Technical Bulletin 219

09.2021

Item: 219.1
Description: Engine Oil and Filter Change
Model Affected: Speed Triple 1200 RS

Item:	219.3
Description:	Chain Rubbing Strip
Model Affected:	Tiger 900, Tiger 900 GT, Tiger 900 Rally, Tiger 900 GT Pro, Tiger 900 Rally Pro, Tiger 900 GT - LRH, Tiger 850 Sport

1. Oil drain plug

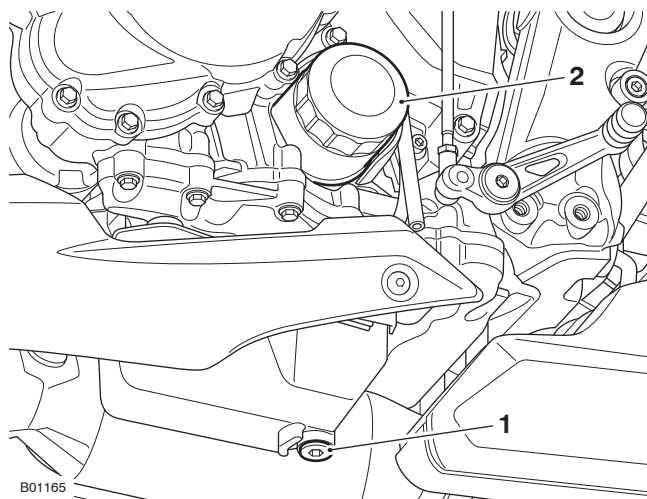
A new procedure for the engine oil and oil filter change has been introduced for the above model. It has come to our attention that on a small number of the above models oil pressure warning light did not extinguish after an engine oil and oil filter change. Dealers should fill the engine with oil before the new oil filter is fitted. The revised procedure is described below.

Always fill the engine with clean oil prior to fitting the new oil filter.

Fitting the new oil filter before filling the engine may cause air to temporarily become trapped in the oil gallery.

Fitting the (dry) oil filter after refilling the engine with oil will prevent the possibility of the low oil pressure warning light illuminating.

- Unscrew and remove the oil filter using **Service tool T3880313 - Oil Filter Wrench**. Dispose of the old oil filter in an environmentally friendly way.
- After the oil has completely drained out, fit a new sealing washer to the drain plug. Fit and tighten the plug to **25 Nm**.

- Fill the engine with a 10W/40 or 10W/50 semi or fully synthetic motorcycle engine oil that meets specification API SH (or higher) and JASO MA, such as Castrol Power 1 Racing 4T 10W-40 (fully synthetic).

1. Fuel hose connector
2. Latch
3. Release button (one of two shown)
4. Fuel rail
5. Fuel hose

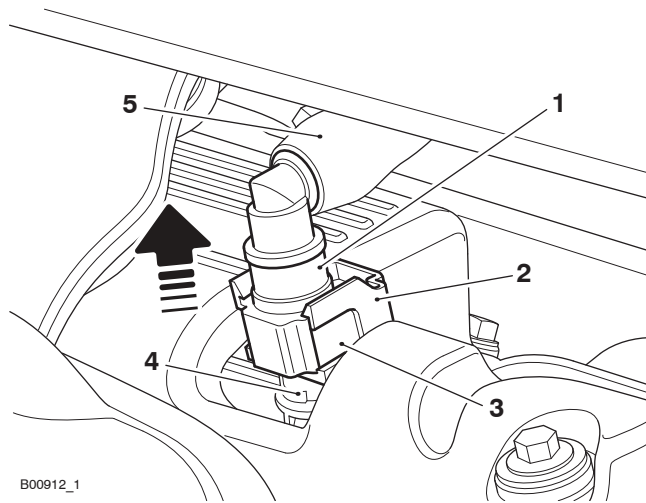
The Service Manual for the above model has been updated to include further information about the fuel line disconnection.

Do not pull on the fuel hose to disconnect the connector from the fuel rail.
Pulling on the fuel hose may damage the fuel hose connector.
Disconnect from the fuel line by lifting up the fuel hose connector.

-
2. Press in the release buttons (one either side of the fuel hose connector) to release the locking device.
 3. Without pulling on the fuel hose, lift up the fuel hose connector to disconnect it from the fuel rail.

Test Rear Preload Motor

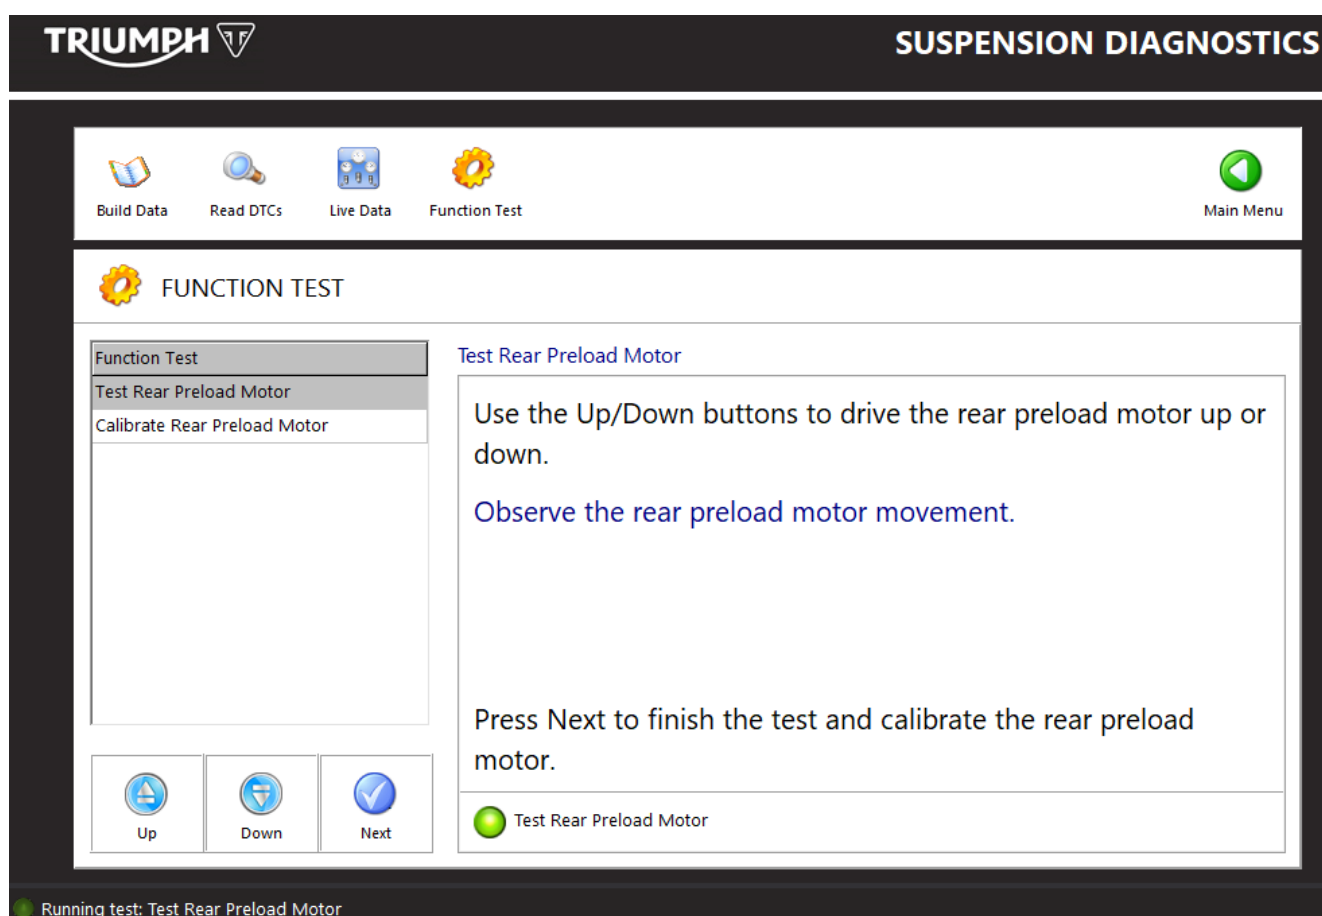
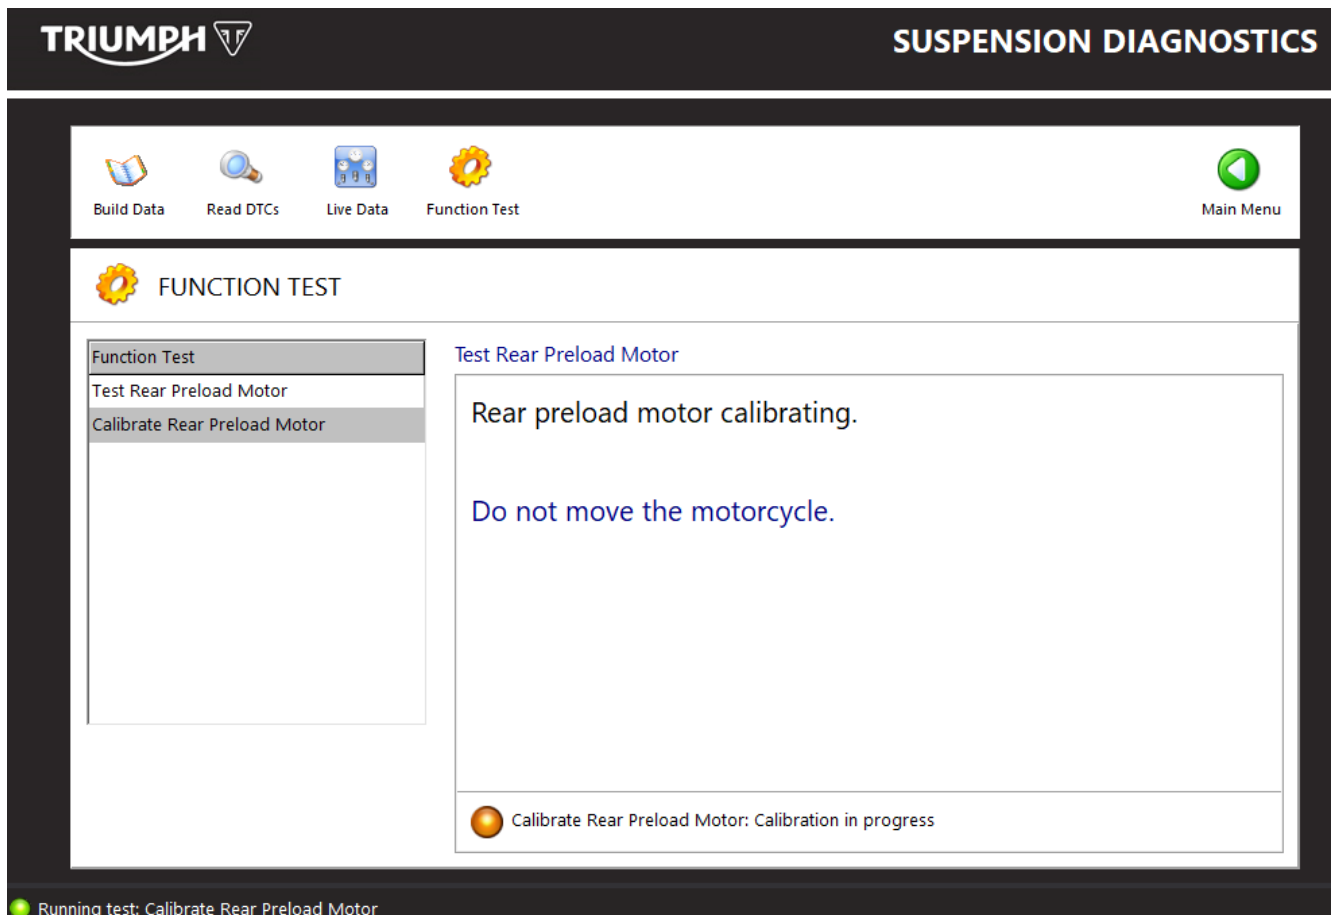
The rear preload motor function tests have been updated for the above model in the Suspension Diagnostics area of the Triumph Diagnostic Tool. The function tests now feature a guided workflow and are available from the TDT 2021-11 update onwards.

There were previously two separate function tests (Rear Preload Motor Up and Rear Preload Motor Down). These have been combined under one rear preload motor function test.

Upon clicking Start, the tool will provide **Up** and **Down** buttons to allow the preload motor to be driven up and down.

A **Next** button is also provided. Upon clicking **Next**, the tool will end the test and will automatically proceed to calibrate the rear preload motor. The tool will display onscreen instructions to guide users through the calibration process as described below.
